Florida Department of Transportation
PROJECT REEVALUATION

- a. Reevaluation Phase: Design Change Authorization
- b. Document Type and Date of Approval: EA/FONSI approved 1/25/93
- c. Project Numbers: RS-7810(4) 258043-1
Federal Aid No. Financial Project No.
- d. Project Local Name, Location and Limits: SR 54 (now SR 56) in Pasco County Florida, from Cypress Creek to the Zephyrhills East Bypass, a distance of approximately 14 miles. (See Attachment C)
- e. Segment of Highway Being Advanced: From SR 581 to Meadow Pointe Boulevard, a total distance of approximately 3.8 miles.
- f. Preparer: Rick Adair

S.R. 56
Design
Change
Reevaluation

ORIGINAL VS. REVISED
ALIGNMENTS

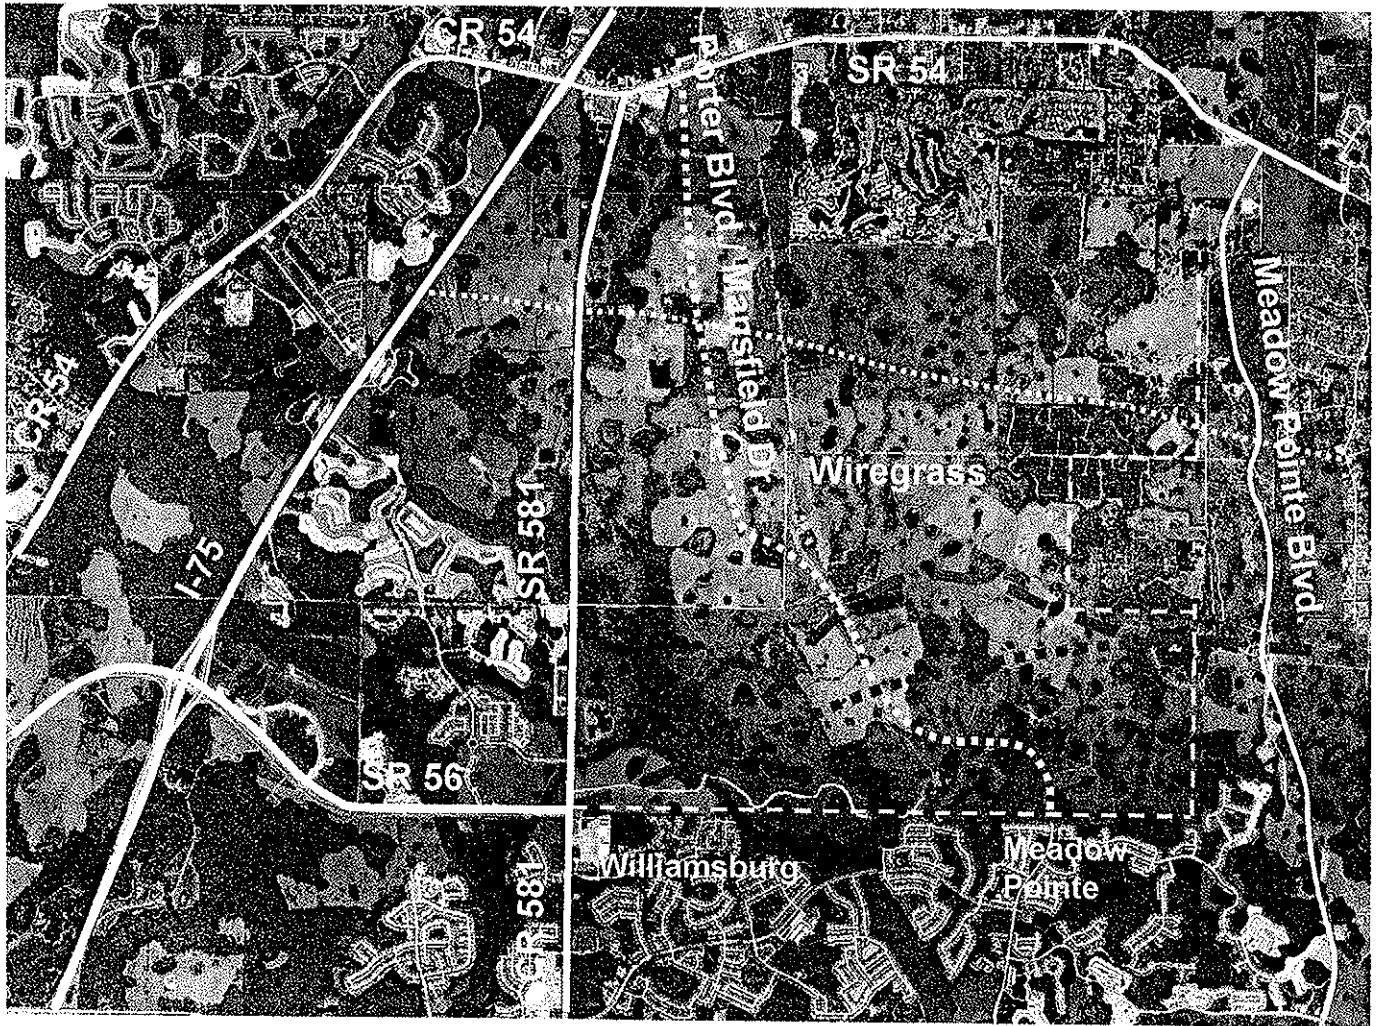
The currently proposed design for the segment of SR 56 from SR 581 to Meadow Pointe Boulevard includes an alignment shift to the north from just east of SR 581 to just west of Meadow Point Boulevard. The proposed shift in alignment compared to the previously approved concept is shown in Figure 2. During the original PD&E Study, the Wiregrass Ranch was a privately owned and operated cattle ranch and a single family residence with no known planned development. This property is currently part of the proposed Wiregrass Ranch Development of Regional Impact (DRI) and this shift in alignment is a result of coordination between the DRI and Pasco County. Because of the shift in alignment, the proposed roadway right-of-way requirements have increased from approximately 409 acres to 417 acres.

Proposed Typical Sections
FIGURE 3

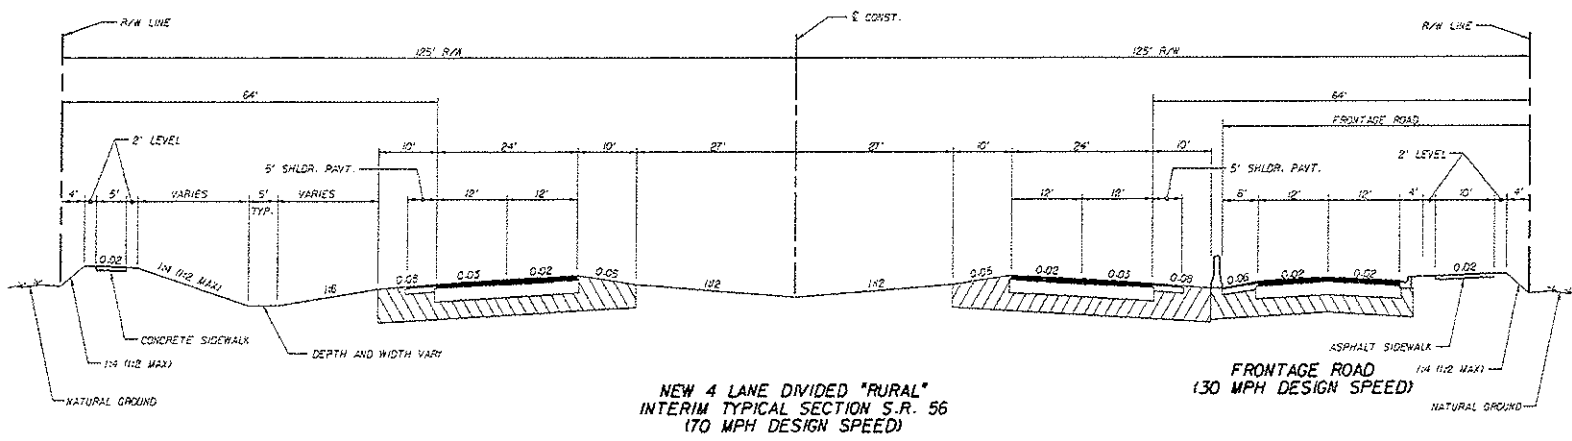
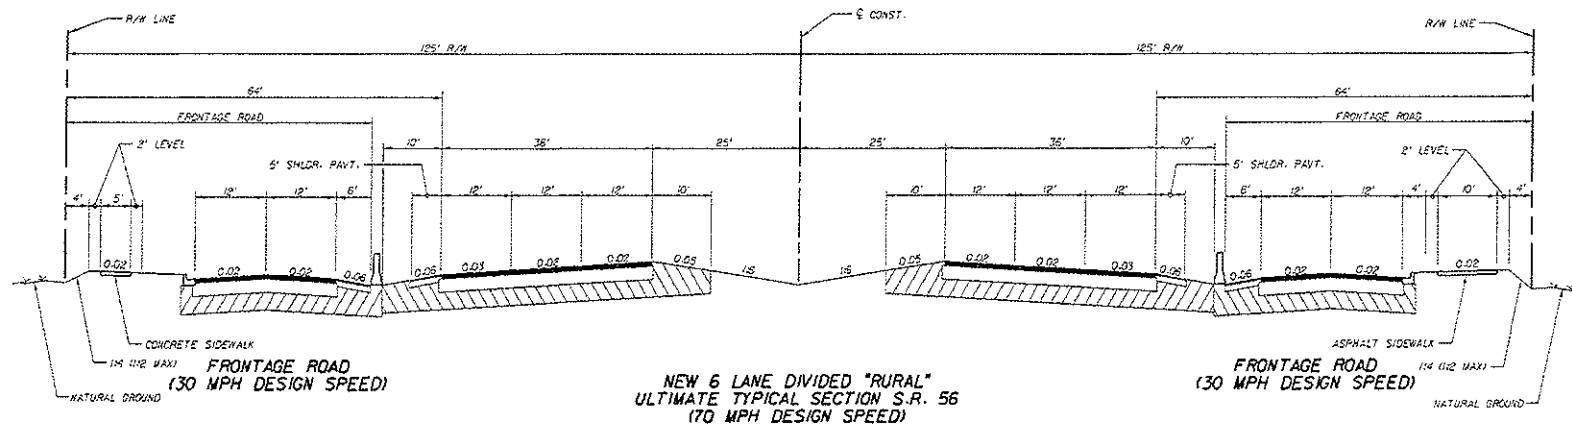
Crescent Properties in the Southeast Quadrant of the SR 581 and SR 56 intersection. It is to be located within SR 56's 250-foot right-of-way (See Figure 3). The frontage road is a two lane two way typical section with 12 foot travel lanes, 6 foot inside shoulder separated from the mainline with a concrete barrier wall. The frontage road is approximately 3000' in length measured from the existing driveway access of Crescent Properties to a planned full median opening eastward along SR 56.

Other than at the above noted location, a reverse or rear frontage road system is to be provided outside of SR 56's 250-foot right-of-way by Pasco County. This is considered to be Phase I of the project's implementation. In the event that the reverse or rear frontage road system provided by Pasco County does adequately meet the traffic demand for the SR 56 corridor, the FDOT will process, for FHWA approval, another design change reevaluation. This reevaluation would indicate that a two way frontage system within SR 56's 250-foot right-of-way is to be constructed. This is considered to be Phase II of the project's implementation. The frontage road will be a two lane two way typical section with 12 foot travel lanes, 6 foot inside shoulder separated from the mainline with a concrete barrier wall (See Figure 3).
